Change Number M-16-01-01	Federal Facility Agreement and Consent Order Change Control Form Do not use blue ink. Type or print using black ink.	Date 1/4/01
Originator EPA/RL (Gadbois/Goldberg)		Phone 376-9844/376-9552
Class of Change <input type="checkbox"/> I - Signatories <input checked="" type="checkbox"/> II - Executive Manager <input type="checkbox"/> III - Project Manager		
Change Title Establish Interim Remedial Action Milestones for the 100-IU-6 Operable Unit (OU)		0054423
Description/Justification of Change This change request establishes new interim milestones to complete remediation of the JA Jones 1 and 600-23 waste sites within the 100-IU-6 OU. These milestones provide for the timely completion of the interim remedial action for these wastes sites. These sites will be remediated as directed by the applicable Record of Decision (ROD) and associated remedial design documents, which includes the remedial design report (DOE/RL-96-17) and the sampling and analysis plan (DOE/RL-96-22). Attached is the information that support the milestones and associated remediation schedule.

**Key Assumptions Affecting Schedule and Milestone for Remediation of JA Jones 1 and 600-23
Waste Si

Figure 1: JA Jones and 600-1 Site Boundary

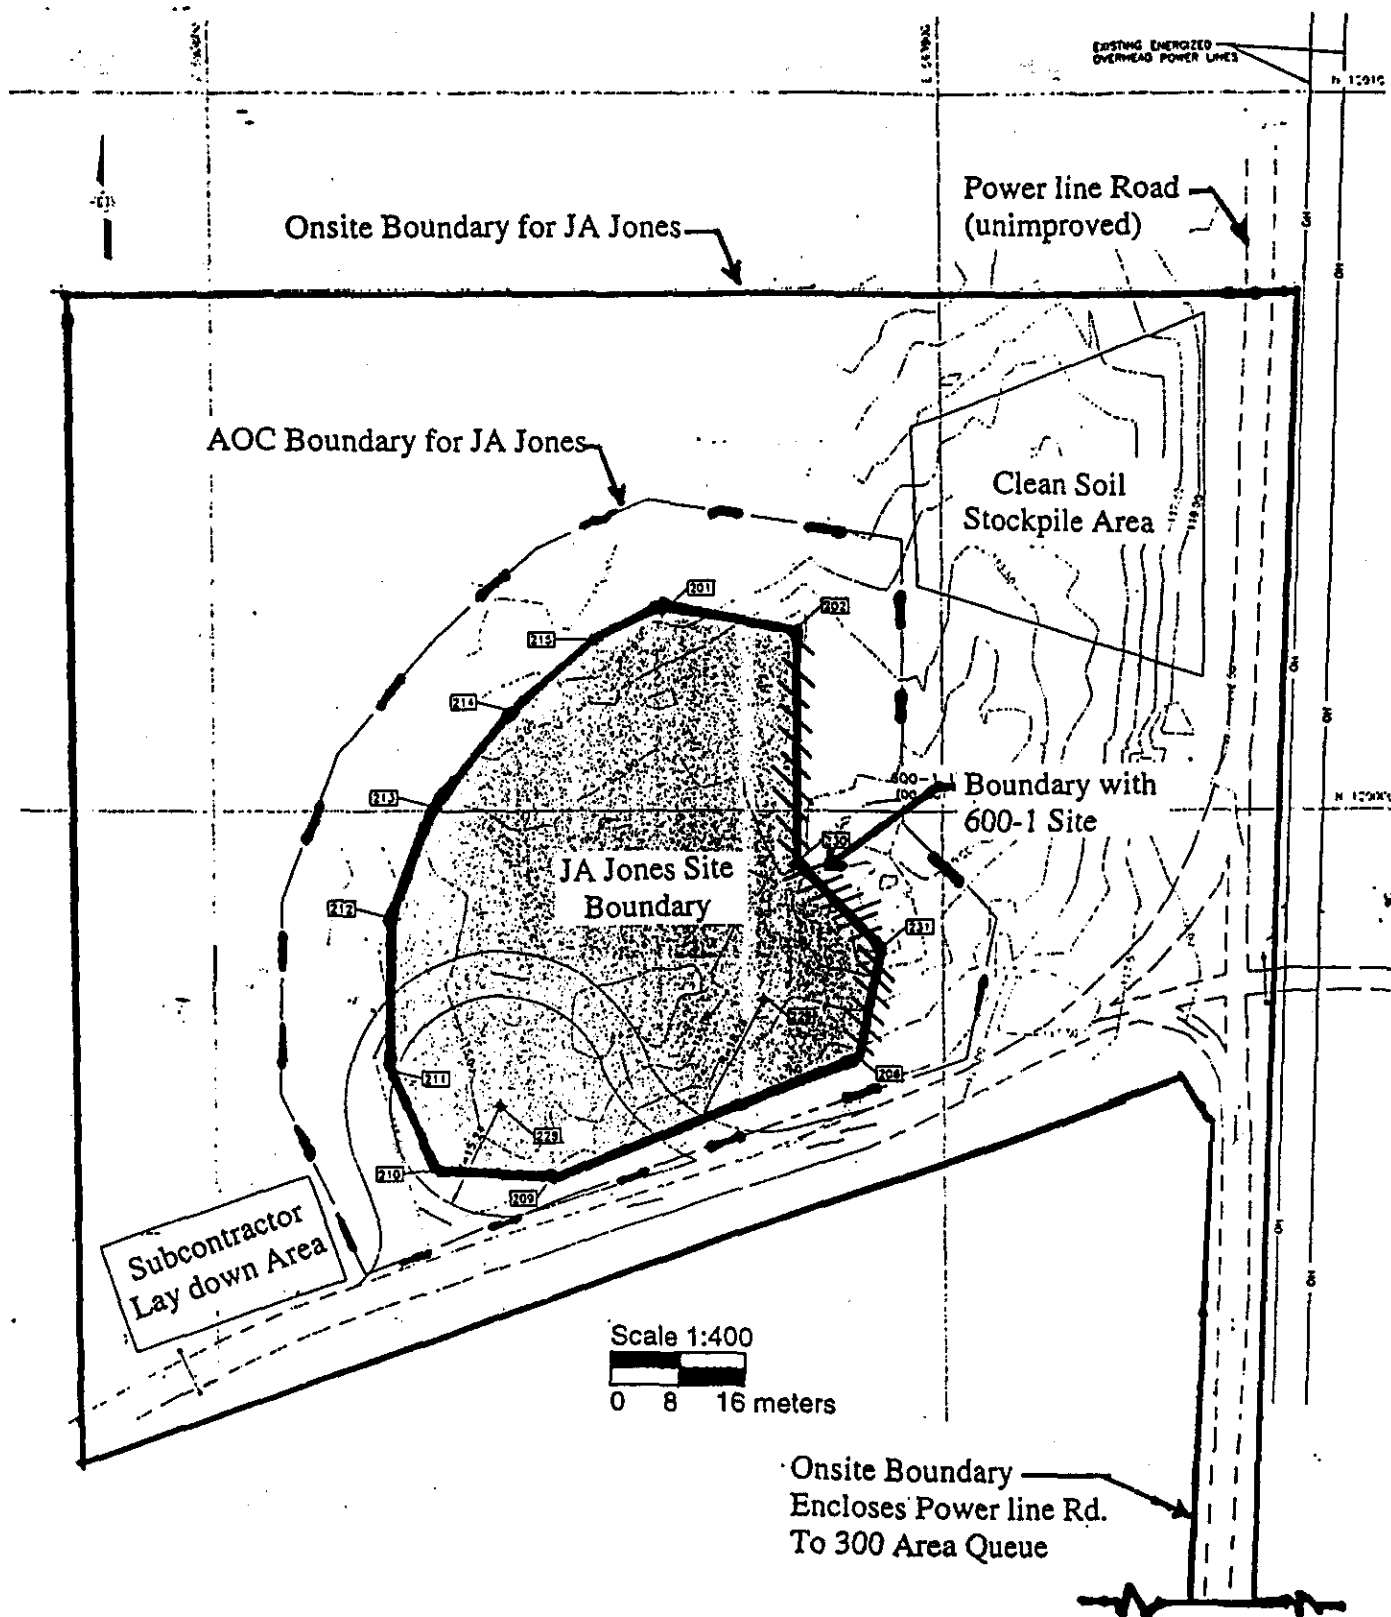
- The physical boundary between the JA Jones 1 site (to be excavated) and the 600-1 waste site (no action) is depicted in attached Figure 1 as can best be determined from WIDS descriptions and interpretation of surface geophysical data. Excavation beyond this boundary is considered a plume.
